Rezoning Transportation Analysis

Petition Number: 2021-154

Date	Description
12-28-2021	First Review (KP)

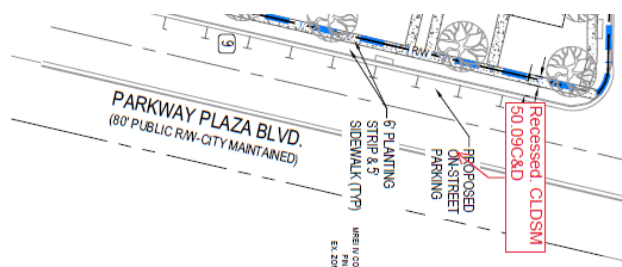
3. Revise site plan and conditional note III.d to commit to construct an 8-foot planting strip and 6-foot sidewalk along the site's frontage of Price Lane and Parkway Plaza Boulevard. The site plan shall label and dimension both items from the back of curb and gutter and road centerline.

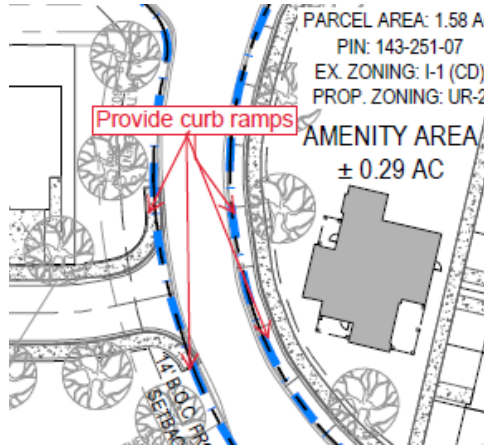
5. Revise the site plan by showing the missing 8 townhomes.

Please show the 8 units on the site plan

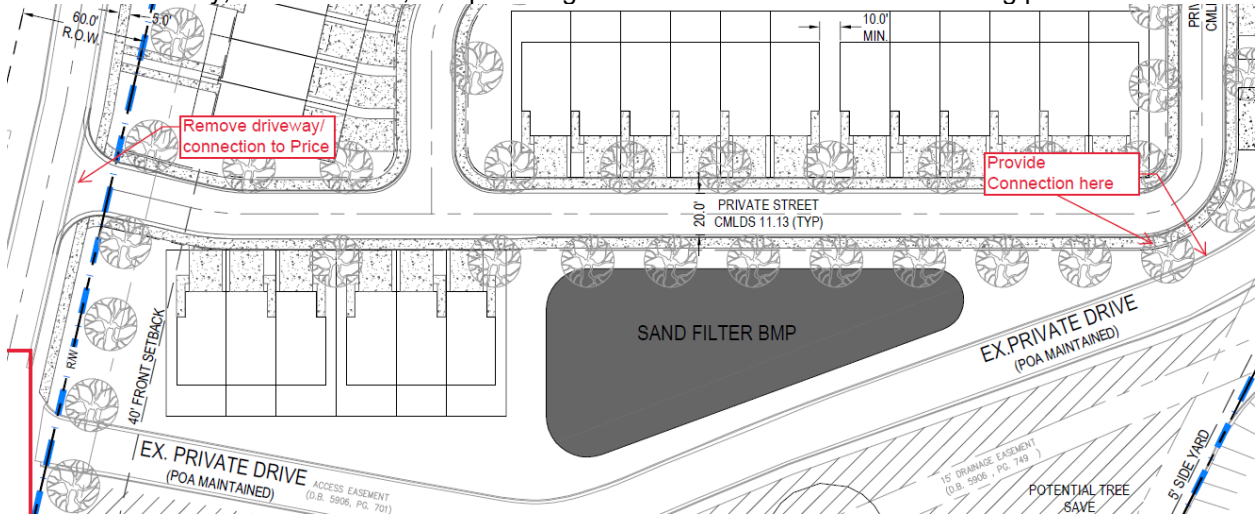
6. Revise the site plan to commit to provide four ADA curb ramps at the proposed private street intersection near the amenity area.
